INFORMATION BULLETIN

TI Software V15.1.52

| Applies to the Following Projectors | Prepared for |
|-------------------------------------|--|
| All Series 1 CP2000 Projectors | External Operators and Service Technicians |

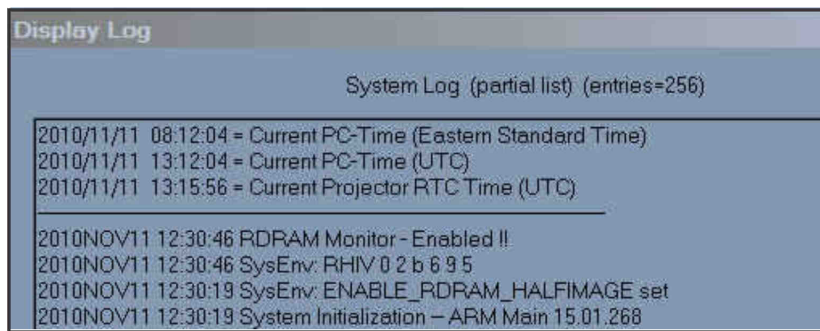
- Install TI v15.1.52 software as per normal installation instructions using the TI control application.
- **If required for ½ image issues** install the system.env file (ENV Variable) (located in the V15.1.52 package) in the File –sys>Root Directory using the DLP Control Program> **Put file**. If a previous system.env file is already in the root directory simply delete it.

- Power Cycle the projector
- Login to the TI electronics using the control application again
- View the TI System Logs, you should now see entries similar to below:
